SAFETY RECALL NOTICE NUMBER 110004 (NHTSA RECALL NOTICE 11V-373)

August 2, 2011

Genie Industries, Inc. ("Genie") has decided that a defect which relates to motor vehicle safety exists within the motor controller installed on our TZ-34 and TZ-50 trailer mounted aerial work platform booms. This component is also installed as a service part replacement on TMZ 34/19 and TMZ-50 as P/N 96769 and kit 99854.

TMZ-34 and TMZ-50

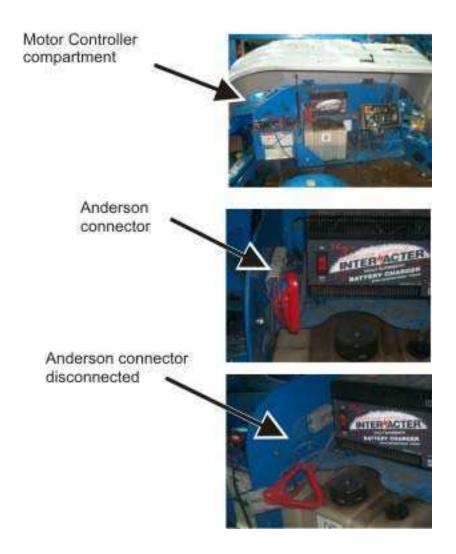
3. Locate the battery pack / motor controller on the machine and disconnect the Anderson connector from the battery pack. Please refer to pages 3 thru 5 for the location of the Anderson connector in your machine.

Note: Disconnect the Anderson connector on your machine only if you have installed P/N 96769 or kit P/N 99854 received from Genie between 4/13/2011 and 7/13/2011.
